Work Order ID 80693

Item Name: Replacement Skidtube

DRAWING NO. D2580	TITLE 205 SKIDTUBE ASSEMBLY	REV. E	DART AEROSPACE LTD ENGINEERING ORDER	D.E.O. NO. D2580-E-1	SHEET NO. SHEET 1 OF 1	SCALE NTS
DRAWN <i>UP</i>	CHECKED <i>ASS</i>	MFG. APPR. <i>ER</i>	APPROVED <i>##</i>	DE APPR. <i>##</i>		
DATE 11.12.13	DATE 11.12.13	DATE 11.12.13	DATE 11.12.13	DATE 11.12.13

CHANGE ALL C'BORED WELDED CROSSBOLT SPACERS TO SWAGED SPACERS

SECTION B-B D5-2
SCALE 5X

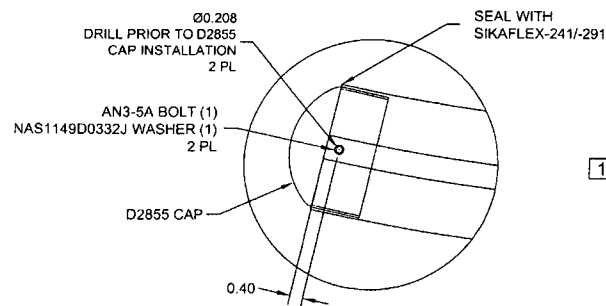
AFTER DRILLING AND BENDING ASSEMBLY
PERFORM THE FOLLOWING FOR Ø0.508 HOLES ONLY:

1. CHAMFER HOLE 0.050 X 45°
2. INSERT D2579 SPACER (20 PLACES)
3. WELD INTO PLACE AND GRIND FLUSH
4. C'BORE D2579 SPACER TO Ø0.437 X 1.00 DEEP

1. INSERT D4202-1 SPACER, 20 PL (-041) OR 20 PL (-045) OR 25 PL (-047)
2. SWAGE TO Ø0.437 X 1.00 DEEP PER QSI 002
3. TRIM / GRIND FLUSH PER QSI 002

SECTION F-F D5-5
SCALE 5X

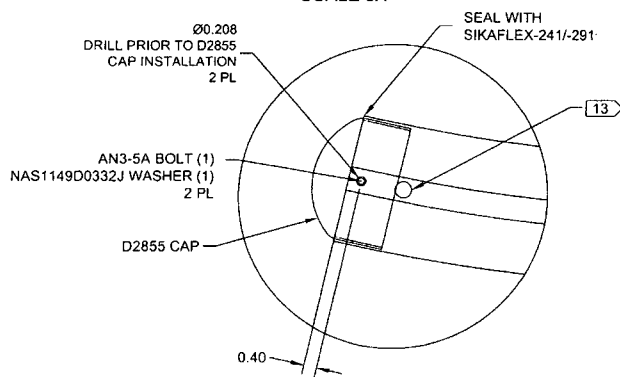
- AFTER DRILLING AND BENDING ASSEMBLY
PERFORM THE FOLLOWING FOR Ø0.508 HOLES ONLY:
1. CHAMFER HOLE 0.050 X 45°
 2. INSERT D2579 SPACER (24 PLACES)
 3. WELD INTO PLACE AND GRIND FLUSH
 4. C'BORE D2579 SPACER TO Ø0.437 X 1.00 DEEP

SECTION I-I D5-7
SCALE 5X

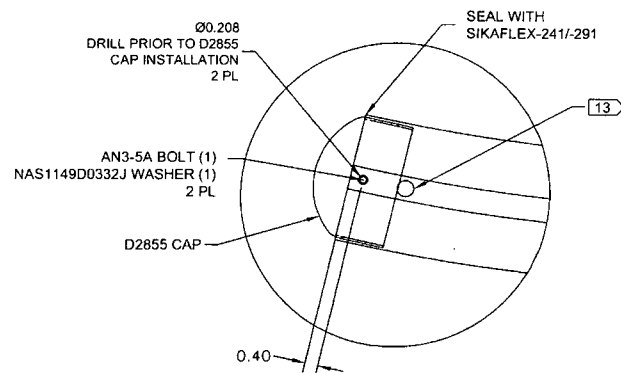
- AFTER DRILLING AND BENDING ASSEMBLY
PERFORM THE FOLLOWING FOR Ø0.508 HOLES ONLY:**
- 1. CHAMFER HOLE 0.050 X 45°**
 - 2. INSERT D2579 SPACER (25 PLACES)**
 - 3. WELD INTO PLACE AND GRIND FLUSH**
 - 4. C'BORE D2579 SPACER TO Ø0.437 X 1.00 DEEP**

SECTION B-B, F-F, I-I
NOT TO SCALE

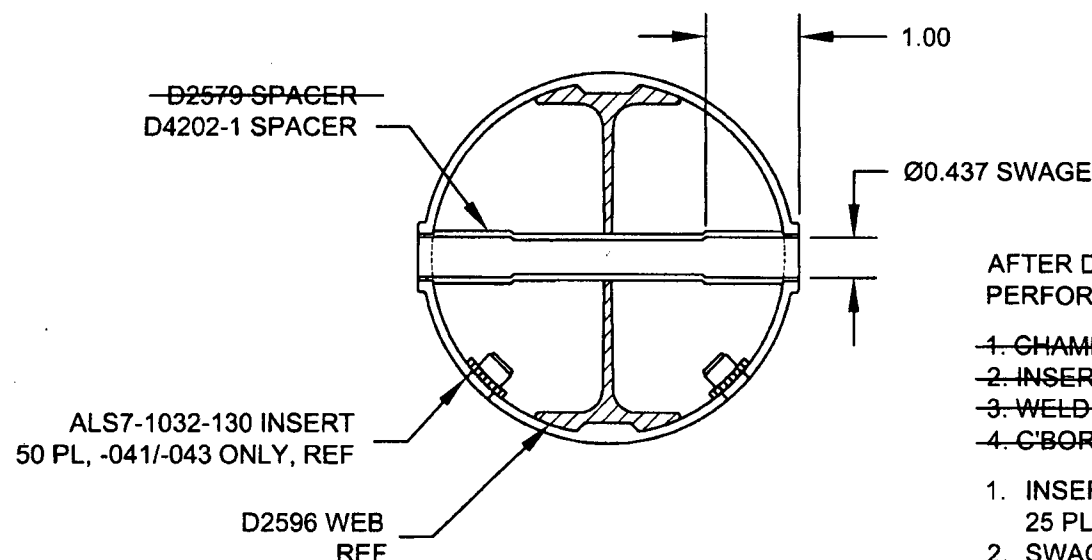
SECTION B-B, SECTION F-F, & SECTION I-I ARE AMENDED AS FOLLOWS
FOR ALL HOLES THAT WERE ORIGINALLY C'BORED:

AFTER DRILLING AND BENDING ASSEMBLY
PERFORM THE FOLLOWING FOR Ø0.508 HOLES ONLY:

1. CHAMFER HOLE 0.050 X 45°
2. INSERT D2579 SPACER (20 PLACES)
3. WELD INTO PLACE AND GRIND FLUSH
4. C'BORE D2579 SPACER TO Ø0.437 X 1.00 DEEP

WELD 4X D2579 SPACERS PER DWG
IN LOCATIONS MARKED "NO C'BORE".
REF SHEET 4 OF DWG.
